SERVICE BULLETIN

ENGINE - TURBINE EXHAUST - REPLACE THE NO. 5 BEARING REAR COVER PACKING WITH A NEW IMPROVED SEAL - CATEGORY CODE 6 - MOD.ENG-72-0173

V2500-ENG-72-0173

Fig.1

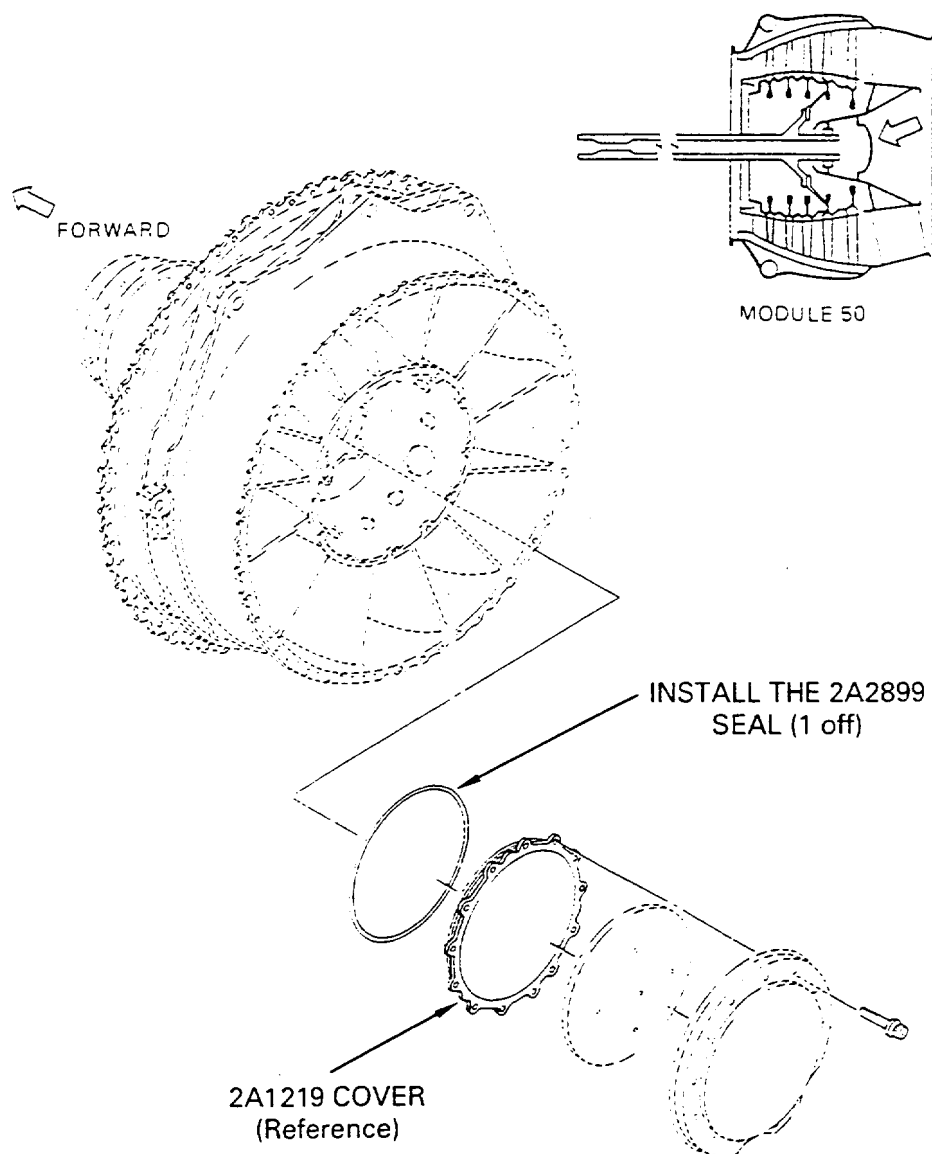
- (a) Install the 2A2913 Seal (No. 5 Bearing Rear Cover) (1 off) by the instructions given in Reference (2), Chapter/Section 72-00-50, Installation-04. See Figures 1, and 3.

Fig.2

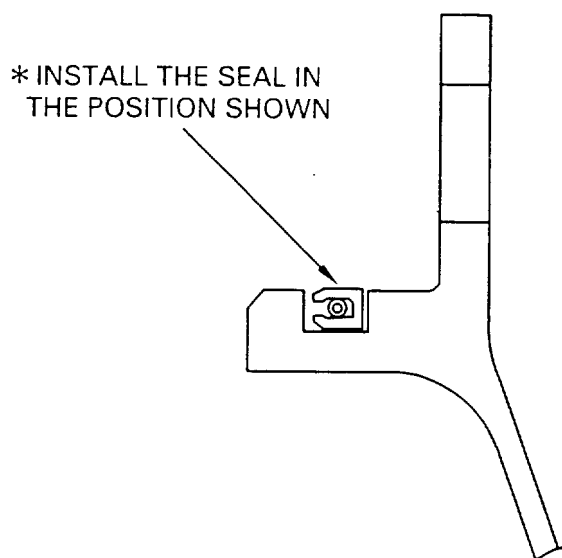
- (a) Install the 2A2899 Seal (No. 5 Bearing Rear Cover) (1 off) by the instructions given in Reference (2), Chapter/Section 72-00-50, Installation-04. See Figures 2, and 3.
